Log # TXX-92416
File # 916
10010
Ref. # 10CFR50.90
10CFR50.36

September 10, 1992

SUBJECT: COMANCHE PEAK STEAM ELECTRIC STATION (CPSES)- UNIT 1
DOCKET NOS. 50-445
SUBMITTAL OF LICENSE AMENDMENT REQUEST 92-04
UNDERVOLTAGE AND UNDERFREQUENCY CHANGES TO
TABLE 2.2-1 OF THE UNIT 1 TECHNICAL SPECIFICATIONS

FIGURE 1

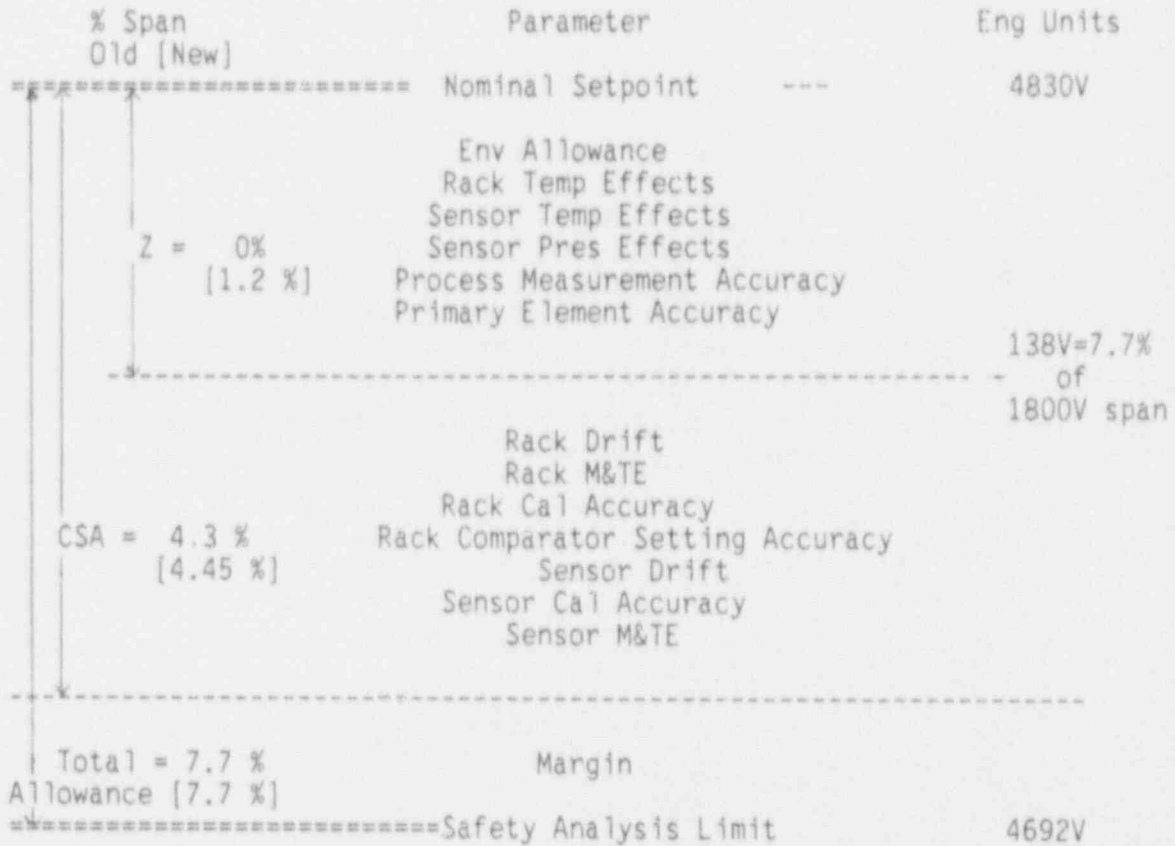
The UV relay senses RCP Bus voltage through a potential transformer. The potential transformer has a primary to secondary winding ratio of 60:1 (7200V:120V) with an uncertainty of 0.3 %. The primary to secondary winding ratio and the associated uncertainty translates to an output voltage, with a 7.2 KV input, of 120 V +/- 0.36 V or +/- 1.2 % of span. Incorporating the potential transformer uncertainty changes the Primary Element Accuracy (PEA) of the Westinghouse Setpoint Methodology from 0.0 % to 1.2 % span. The "Z"

value of Table 2.2.1 of the Technical Specifications is defined in the BASES of the Technical Specifications as being the statistical sum³ of the errors assumed in the analysis excluding those associated with the sensor and rack drift as well as the accuracy of their measurement. WCAP-12123 calculates the "Z" value as the sum of the sensor environmental allowance plus the SRSS of the process measurement accuracy, the primary element accuracy, the sensor temperature effects, the sensor pressure effects, and the rack temperature effects (see figure 1). The "Z" term in Table 2.2.1 of the Technical Specifications for item 14 is changed from 0 % to 1.2 % of span. The Channel Statistical Allowance (CSA) for the UV trip, which uses the same terms as the "Z" term, also changes. The changed CSA is still below the Total Allowance of 7.7 % of span which is listed in Table 2.2.1.

In summary, the addition of the potential transformer uncertainty into the UV relay calculations changes the "Z" value listed in Table 2.2.1 of the Technical Specifications for item 14 from 0.0 to 1.2 % of span. Relaxing the tolerance for the UF relays from 1 % to 2 % of span changes the "Allowable Value" column of Table 2.2.1 of the Technical Specifications for item 15 from 57.1 Hz to 57.06 Hz.

Figure 2

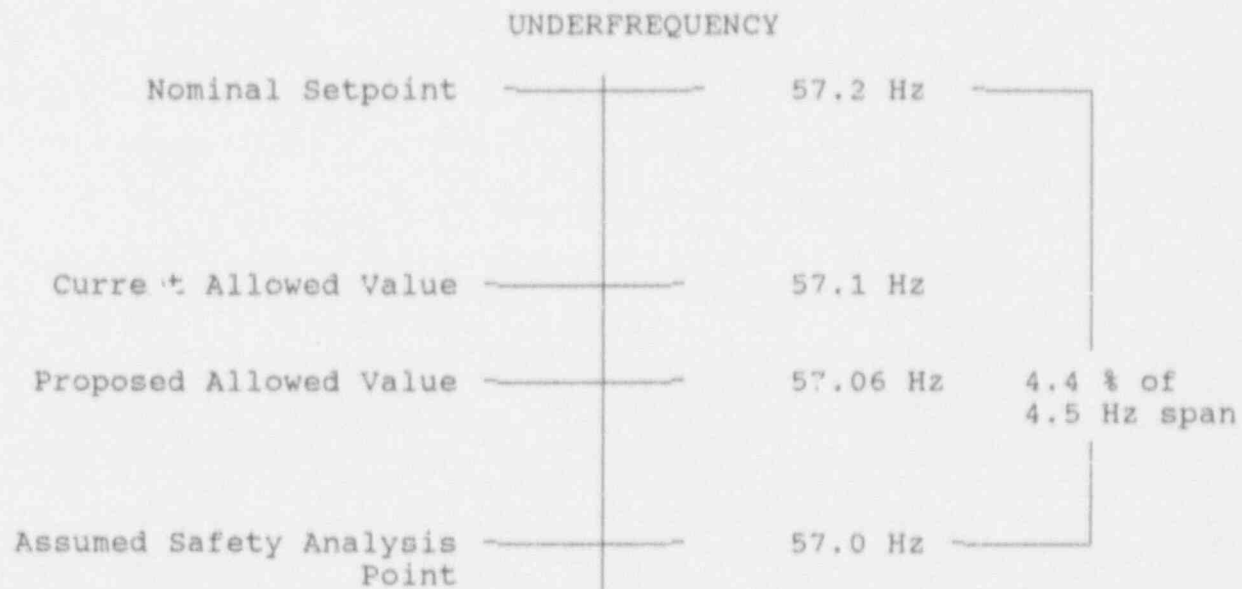
The UF relay monitors the RCP bus frequency and provides backup protection to the UV trip on a complete loss of flow. Westinghouse, in WCAP-12123 assumes that the UF relay is an integral part of the instrument rack and treats the uncertainties as part of the rack uncertainties. Relaxing the UF relay adjustment tolerance from 1 % to 2 % of span will change the various terms used in determining the Channel Statistical Allowance (see figure 2). From the attached TU Electric Reactor Engineering Calculation; "RXE-TA-CP1/0-027, Rev. 1," relaxing the relay adjustment tolerance changes the Rack Calibration Accuracy (RCA) from 1 % to 2 %, the Rack Measuring and Test Equipment (RMTE) allowance from 0.34 % to 0.5 %, and the Channel Statistical Allowance (CSA) from 2.01 % to 3.17 %. The Allowable Value⁴ of Table 2.2.1 of the Technical

specifications is defined in WCAP-12123 as the nominal setpoint plus the arithmetic sum of the instrument uncertainties (i.e., rack drift, rack temperature effects, measuring and test equipment allowance, and the rack calibration accuracy). The change in UF relay tolerance, from 1 % to 2 % of span results in an Allowable Value change to Table 2.2.1 of the Technical Specifications for item 15 from 57.1 Hz to 57.06 Hz. Although the Allowable Value for the UF relay is closer to the Nominal setpoint assumed in the accident analysis and the CSA increases from 2.01 % to 3.17 % of span, the Total Allowance (TA)⁵, at 4.4 % of span, is still greater than the CSA.
